**City of Portland, Maine – Building or Use Permit Application**, 389 Congress Street, 04101, Tel: (207) 874-8703, FAX: 874-8716

Location of Construction: 117 Winter St		Owner: Henry A. Claws		Phone:		Permit No: 970807	
Owner Address: 119 Winter St Apt 1B Portland, ME 04102		Lessee/Buyer's Name:		Phone:		Business Name:	
Contractor Name: Henry Claws SAA		Address: 772-3299		Phone:		Permit Issued: JUL 29 1997 CITY OF PORTLAND	
Past Use: 5-fam		Proposed Use: 2296 4-fam w/int reno		COST OF WORK: \$ 10,000.00		PERMIT FEE: \$ 70.00	
Proposed Project Description: Make Interior Renovations Apts 1, 2 & 3		1st fl/Apt 1 & 2 2nd fl/Apt 3 3rd fl/Apt 4		FIRE DEPT. <input type="checkbox"/> Approved <input type="checkbox"/> Denied		INSPECTION: Use Group: Type:	
Permit Taken By: Mary Greshk		Date Applied For: 23 July 1997		Signature: [Signature]		Signature: [Signature]	
				PEDESTRIAN ACTIVITIES DISTRICT (P.A.D.) Action: <input type="checkbox"/> Approved <input type="checkbox"/> Approved with Conditions <input type="checkbox"/> Denied		Zoning Approval: OK [Signature] 7/25/97 Special Zone or Reviews: <input type="checkbox"/> Shoreland <input type="checkbox"/> Wetland <input type="checkbox"/> Flood Z

117 Winter St.  
2nd Floor  
1/4" = 1'0"

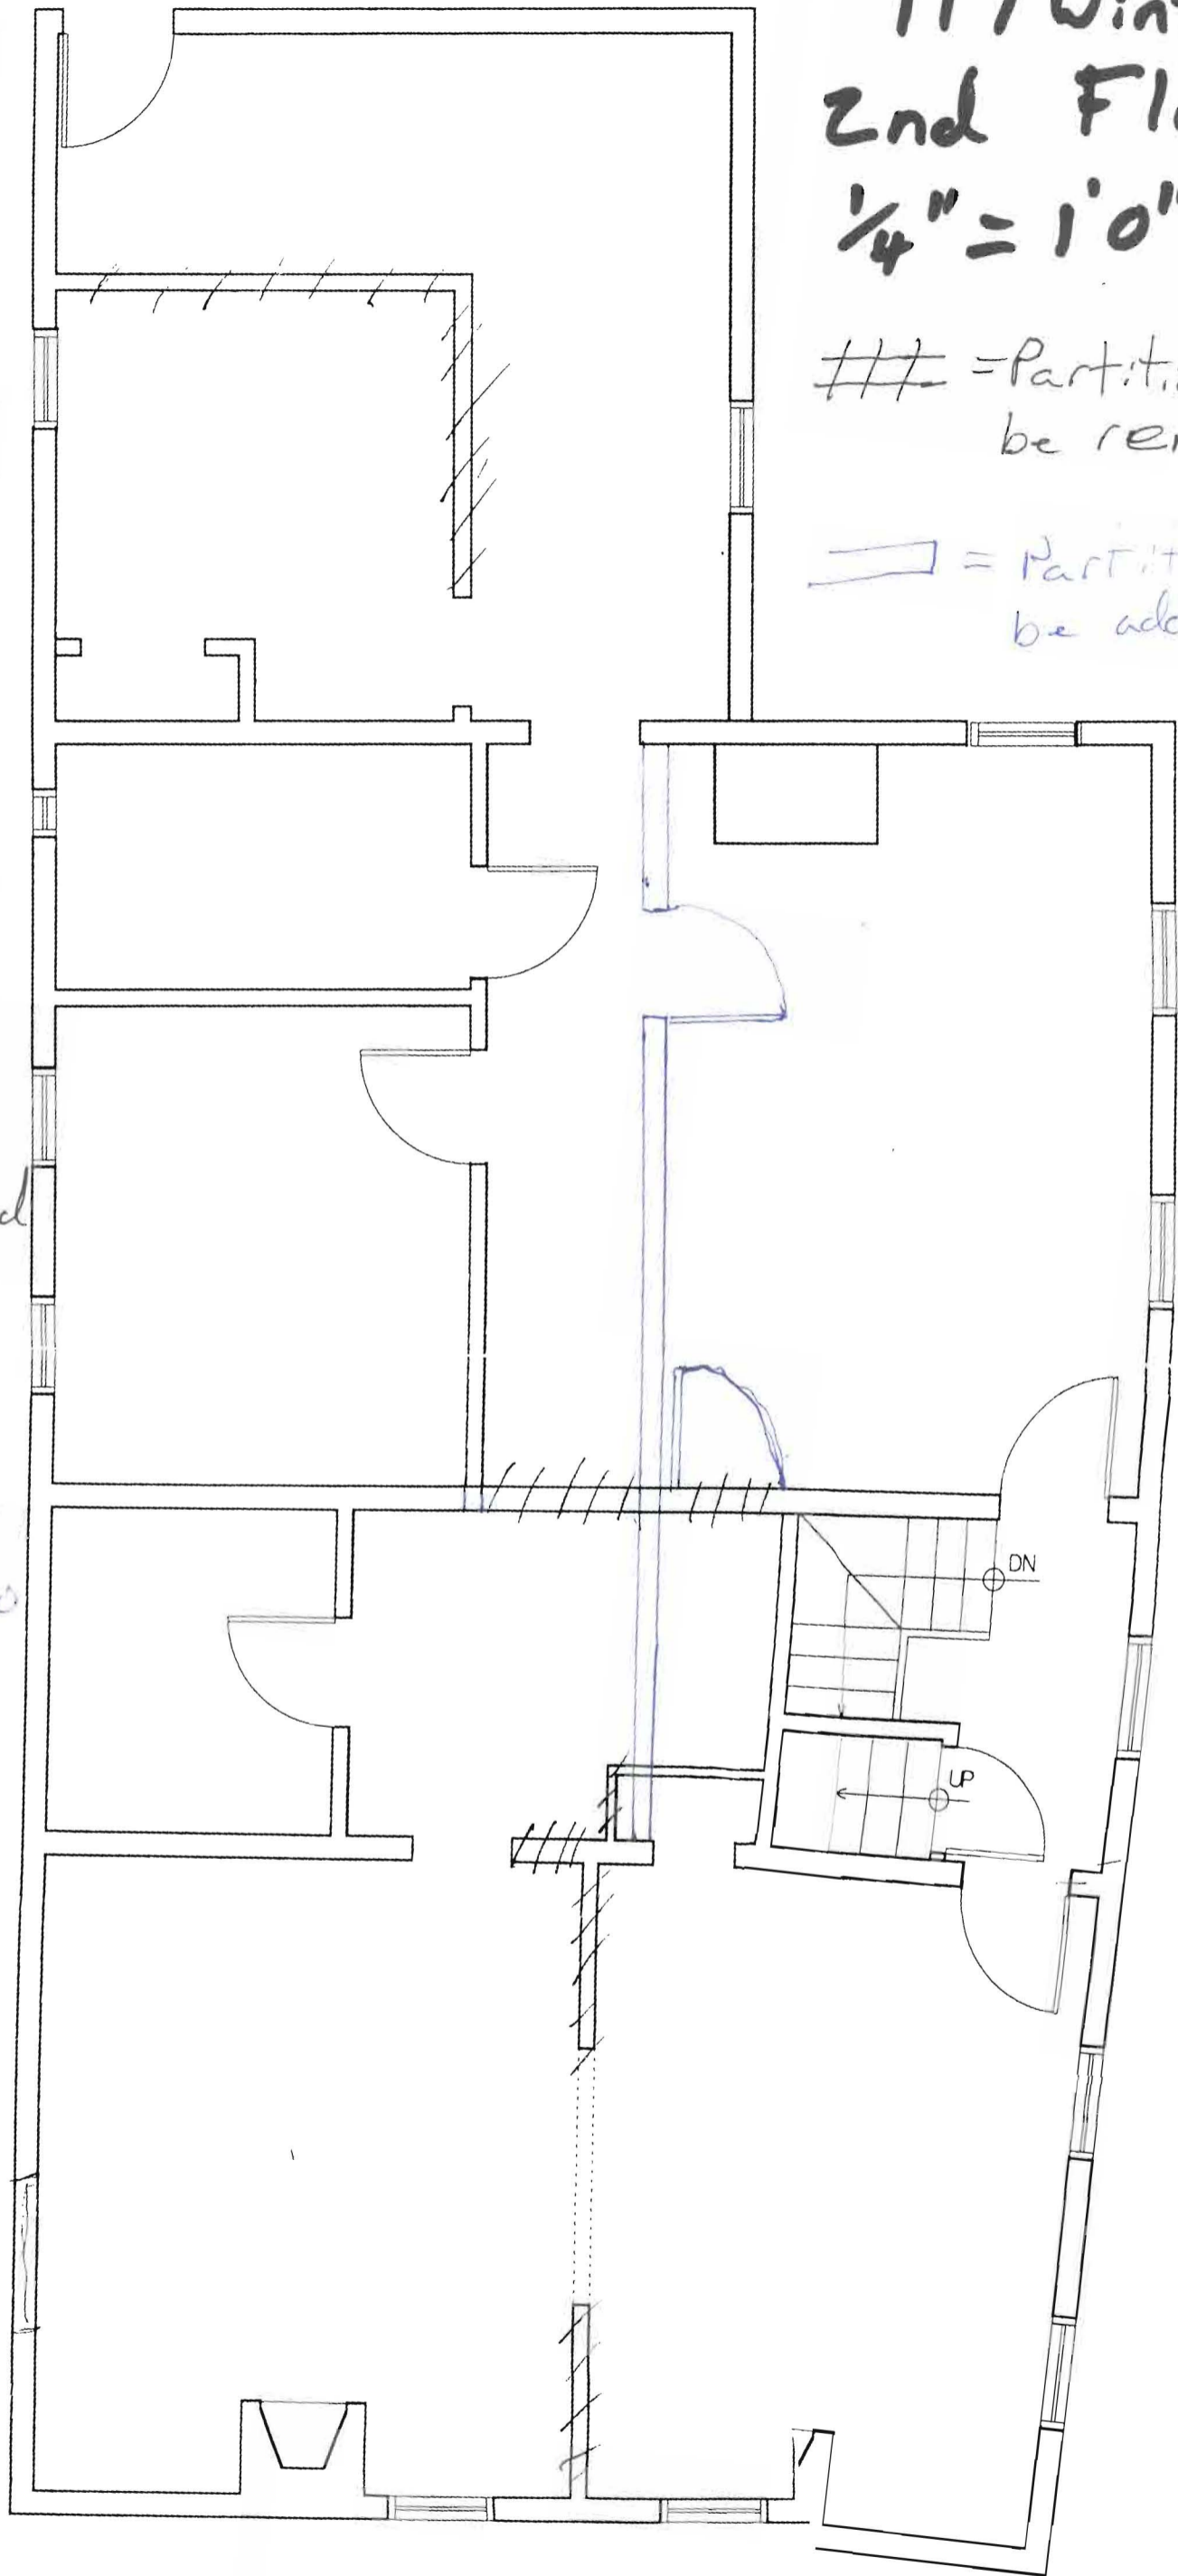
8/16/99 original permit amended on 3/15/98 Vackling 574 and keeping it as a 5 story. w/ Removition of floor plan changes on 2nd - See Requirements for Amendment.

2nd Floor  
to combine  
Apt 3 + 4 into  
one Apt

Approved with the following conditions: X1, X13, X16, X24, X29

## First Floor

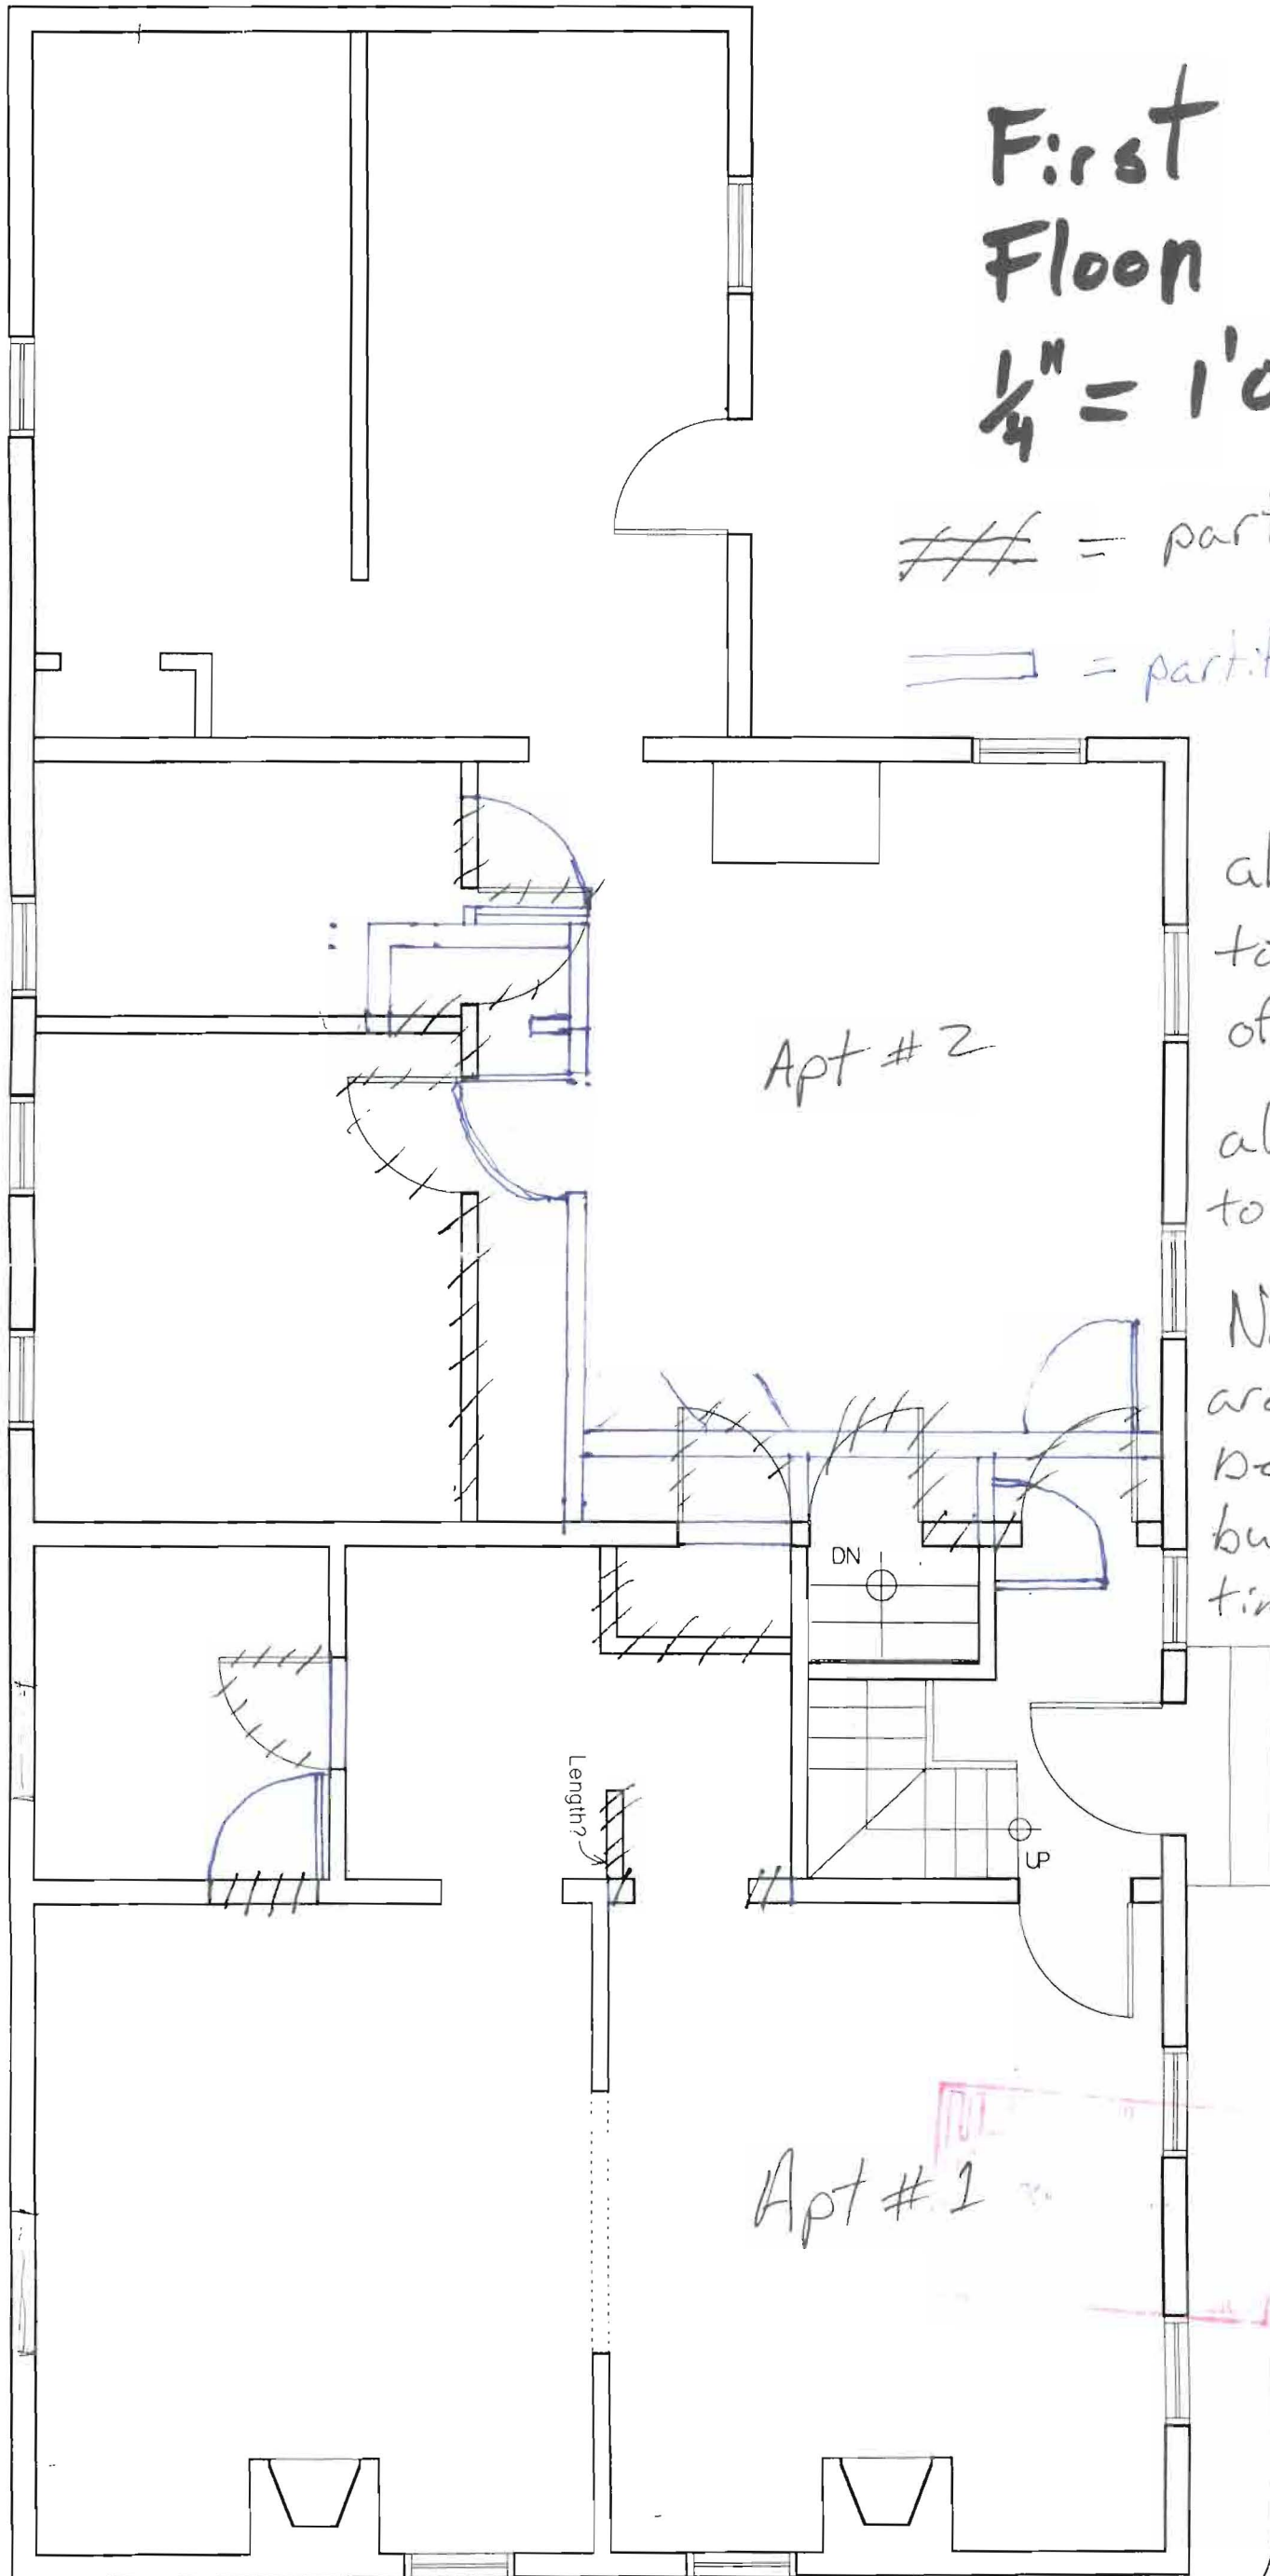
Length?
